RESPONSES TO NRC REQUEST FOR INFORMATION

MARK 1 TORUS PROGRAM PLANT UNIQUE REPORT

VERMONT YANKEE NUCLEAR STATION

JUNE 10, 1983

FIELD INSTALLATION DETAILS
 FOR SRV LINE
 AND 'T' QUENCHER

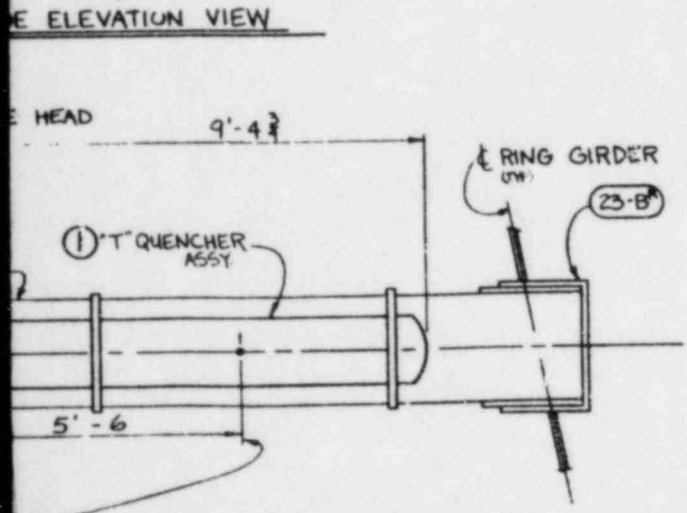
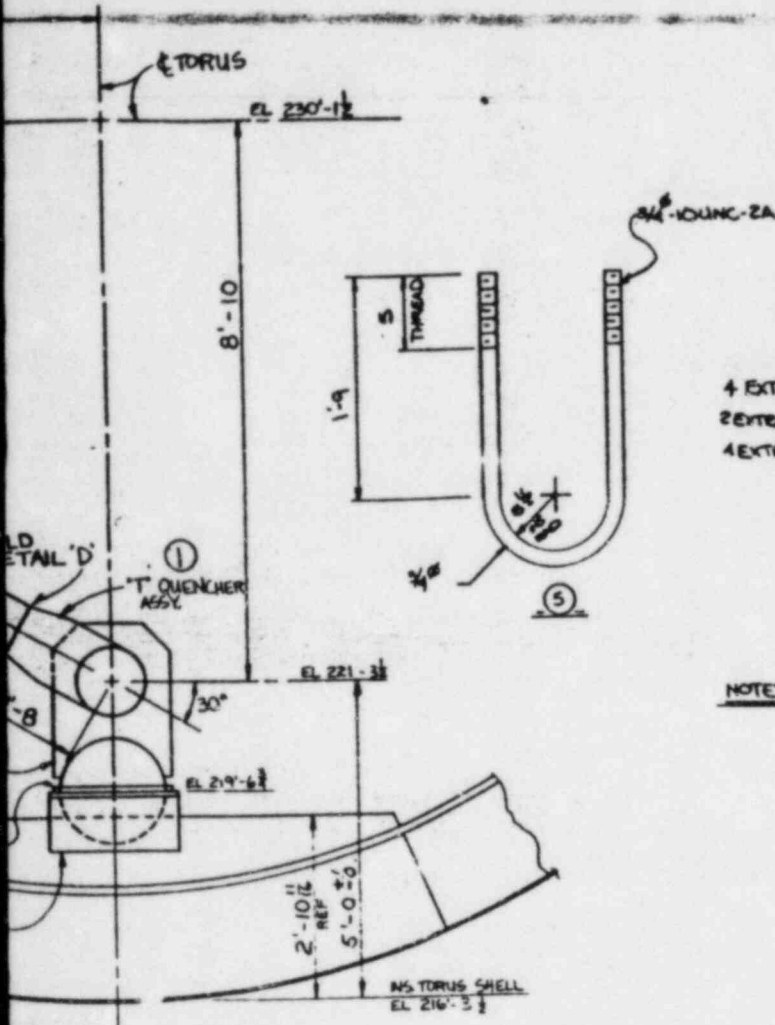
Provide details of the construction of the SRV line as it exists in the Vermont Yankee plant, specifically in the region of the elbow support, if any.

The details of the Safety Relief Valve Discharge Line elbow support and a typical isometric of an SRVDL are included for your review. Note that all four SRVDL's are identical from the vent pipe penetration to the quencher support.
